A meeting of the ARGYLL AND BUTE LOCAL REVIEW BODY will be held in the COUNCIL CHAMBERS, KILMORY, LOCHGILPHEAD on FRIDAY, 15 FEBRUARY 2013 at 10:30 AM, which you are requested to attend.

- 1. APOLOGIES FOR ABSENCE
- 2. DECLARATIONS OF INTEREST (IF ANY)
- 3. CONSIDER NOTICE OF REVIEW REQUEST: LAND SOUTH EAST OF CROISH HOUSE, CAOLES, ISLE OF TIREE, ARGYLL, PA77 6TS
 - (a) Notice of Review and Supporting Documentation (Pages 1 48)
 - (b) Comments from Interested Parties
 - i) Planning Authority (Pages 49 72)
 - ii) Statutory Consultee Roads (Pages 73 74)
 - iii) Statutory Consultee MOD (Pages 75 76)
 - (c) Comments from Applicant (Pages 77 80)

Review of Application 12/00619/PP

PLANNING PERMISSION REFERENCE NUMBER 12/00619/PP

Recommended observation distance: 68 cm
Photo exposed: 25/02/2012 10:00:00
Lens: 100 mm Film: 35x26 mm Pixels: 1280x960
Eye point: British National Grid (AIRY) East: 104,879 North: 745,713
Wind direction: 0° Direction of photo: 44°
Software: WindPRO version 2.7.490 Sep 2011
Photo desc.: A Pier

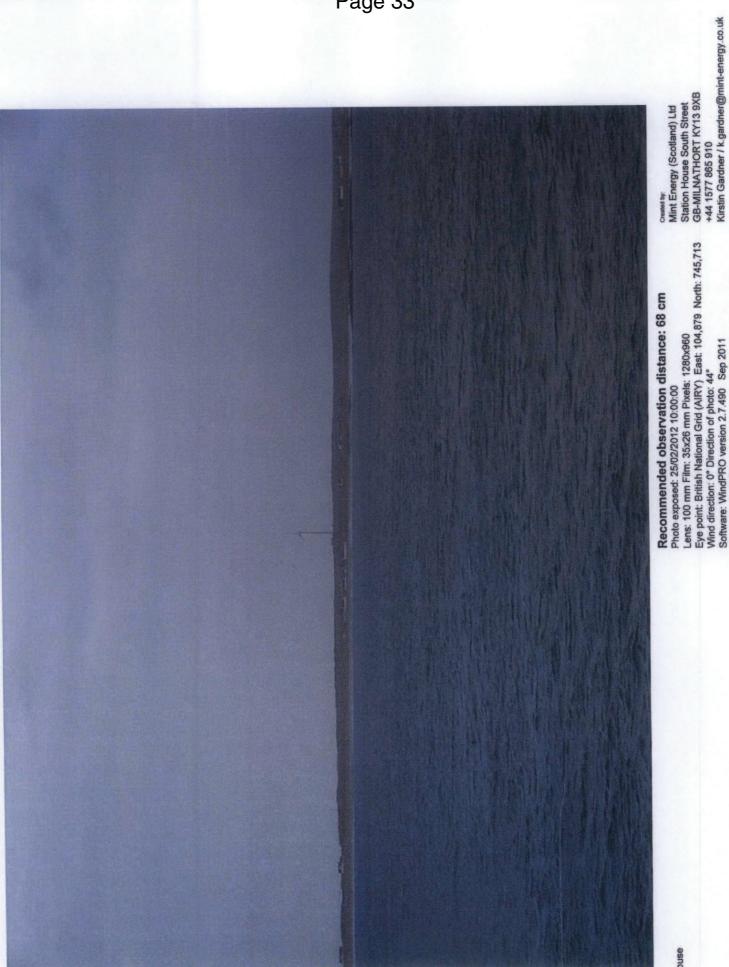
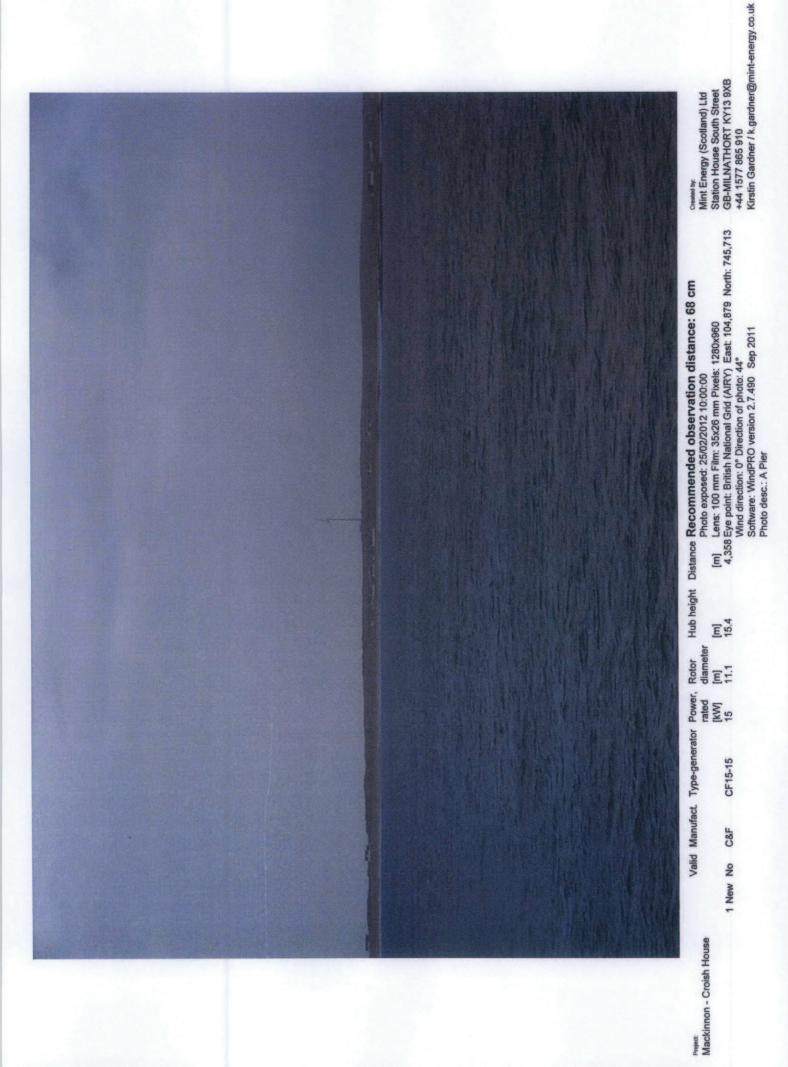
Views from the ferry approach from Coll to Tiree into the site will be significant as demonstrated by the appellants own submission of Zone of Theoretical Visibility (ZTV) and the photomontages. The applicants' own ZTV, referred to as a Zone of Visible Influence (ZVI), demonstrates that the turbine will be highly visible from the ferry route and even at 2km – 3km the turbine will be skylined and very visible. The ZTV is of poor quality and does not differentiate which parts of the turbine will be visible i.e. hub or blades. The ZTV does provide details that the turbine will be visible across much of the island including Gott Bay and the eastern side of the island. It is accepted that this is a theoretical piece of work that does not take into consideration vegetation but Tiree is extremely flat and visibility across long stretches of the island are good.

The photomontages are also of equally poor quality and make it difficult to carry out assessment. However, upon a site visit it is considered that the turbine will be significantly visible from the ferry route. The relevant photomontage does show the turbine to the right of the community turbine completely skylined and from this view it
